# UNITED STATES PATENT AND TRADEMARK OFFICE

APPLICATION NO.	FILING DATE	FIRST NAMED INVENTOR	ATTORNEY DOCKET NO.	CONFIRMATION NO.
10/550,504	09/22/2005	Tomohiro Yamada	28953.7287	9973
27890	7590	09/18/2007		
STEPTOE & JOHNSON LLP 1330 CONNECTICUT AVENUE, N.W. WASHINGTON, DC 20036			EXAMINER GUGLIOTTA, NICOLE T	
			ART UNIT 1709	PAPER NUMBER
			MAIL DATE 09/18/2007	DELIVERY MODE PAPER

### **DETAILED ACTION**

**FIG. 6**

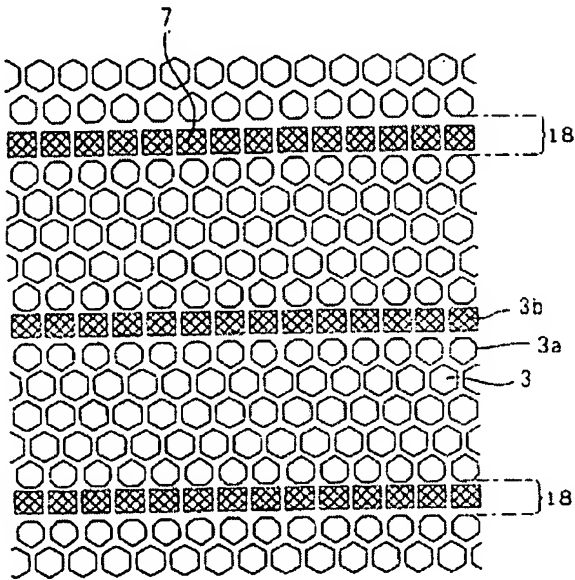
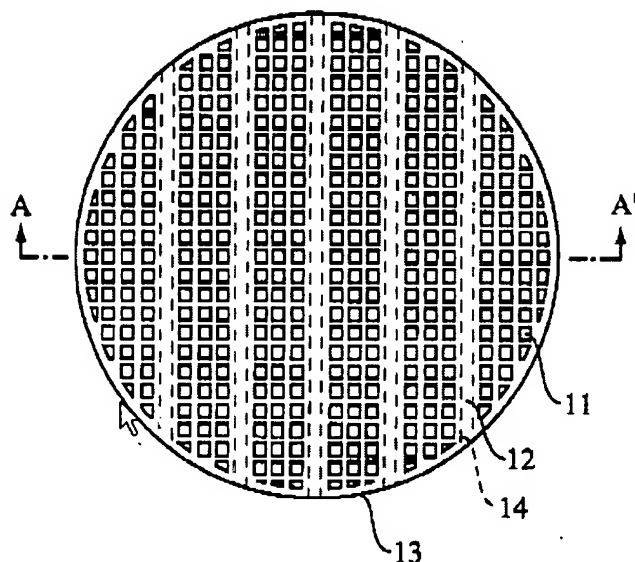
8. In regard to claim 1, Yorita et al. disclose a monolithic ceramic filter comprising filtrate discharging conduit openings and communication voids separated from cells of a honeycomb structure of the filter by cell partition walls, with the voids and conduit opening being in communication with the lateral outside of the honeycomb structure. The voids continue axially through the honeycomb structure and the conduit openings are perpendicular to the long axis of the honeycomb (Column 2, Lines 18 – 23, Column 6, Line 62 – Column 7, Line 6). The filtrate discharging conduit openings (14) are equivalent to applicant's slit-like auxiliary flow passages (Column 5, Lines 8 – 13, Figures 2 & 3). Filtration through a filtration membrane before the filtrate is purified inside the porous ceramic walls and discharged out of an outer wall (Column 3, Lines 23 – 39, and Fig. 10). The cross-section cells may be other polygonal shapes, besides squares. Therefore, heptagonal squares may also be used. (Column 5, Lines 61 – 64).

9. In regard to claim 2, Yorita et al. teach two or more sets of parallel lines, each set comprising two parallel lines (Fig. 2).

12. In regard to claim 5, it is evident by Figures 1 & 2 in the Yorita et al. that a repeated pattern of rows of main flow passages, which are arranged subsequently to one row of second specific main flow passages.

13. It would be obvious to one skilled in the art at the time the invention was made to manufacture a ceramic honeycomb with main flow passages and secondary passages that communicate with the outside of the structure. While Yorita et al. may use different polygon shapes, it has been stated in their patent that any polygon shape may be used for the cross-section cells and the transverse cells. Yorita et al. does not speak of main flow passages vs. first specific main flow passages because it is unnecessary. All of the raw fluid supply passages (equivalent to main flow passages and first specific main flow passages) are of the same polygon shape. However, changing the shape of selected cells and referring to them by a different name does not change their function. What the applicant refers to as main flow passages and specific main flow passages serve the same purpose. The partition wall (12) and filtrate discharge openings (14) of U.S. Patent No. 5,855, 781 serve the same purpose as applicant's specific partition wall part and second specific main flow passage, respectively.

FIG. 1(b)

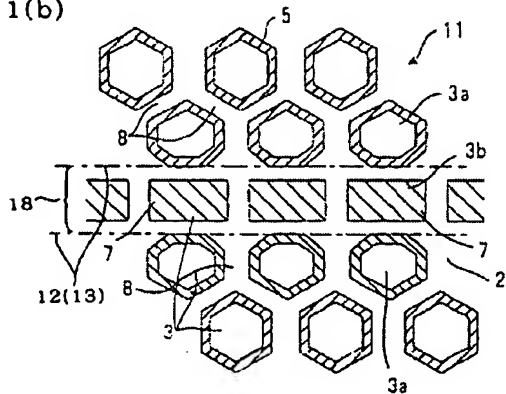
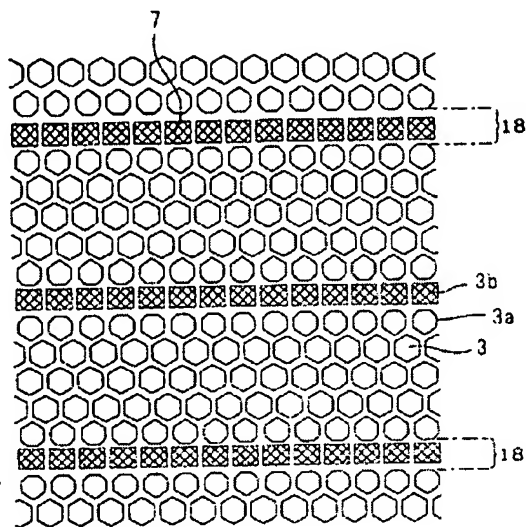
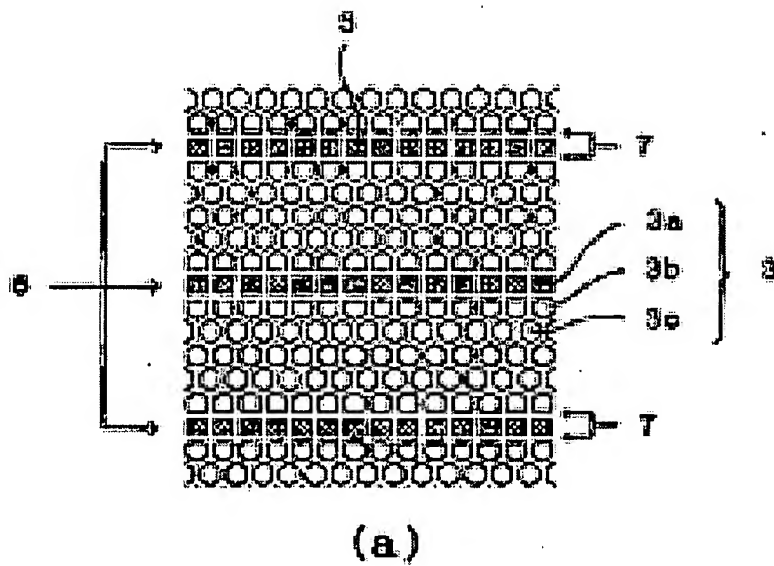
15. In regard to claim 1, Yasuo et al. teaches the same ceramic honeycomb filter claimed by applicant. There would be a main flow passage of hexagonal cells, as well as second specific main flow passages of rectangular cells. The only difference between applicant's claimed invention and the invention of Yasuo et al. is that the first specific main flow passages are pentagonal shaped cells (what Yasuo et al. refers to as "5 angle cells"), instead of heptagonal shaped cells, which are arranged between the hexagonal and rectangular flow cells.

16. In regard to claim 2, 2 or more sets of parallel lines, each set comprising two parallel lines, can be easily seen by Drawings 1a, 3a, 3b, 5 and 4a. Yasuo et al. also describe these parallel lines in Sections 0030 and 0032.

19. In regard to claim 5, Yasuo et al. teach a total of 18 straight-line-like cell walls formed on both sides of a nine-row cell train (Section 34). Drawings 1a and 5 demonstrate 3 main flow passages arranged subsequently to one row of second specific main flow passages. Drawing 4a demonstrates 5 main flow passages arranged subsequent to one row of second specific main flow passages.

It would be obvious to one skilled in the art at the time the invention was made to insert heptagonal shaped cells in place of the pentagonal shaped cells, due to their similar characteristics. Both heptagonal and pentagonal shaped cells would provide a flat side that would be flush with the straight rectangular cells, while still fitting nicely between the hexagonal cells on the opposite side. For a visual comparison, drawings from each

application are shown below. Applicant has shown in Fig.1 (b) and Fig.6 the heptagonal cells (3a) and in the drawing (a) below that Yasuo et al. demonstrates the second specific main flow passages to be pentagonal cells (3b).
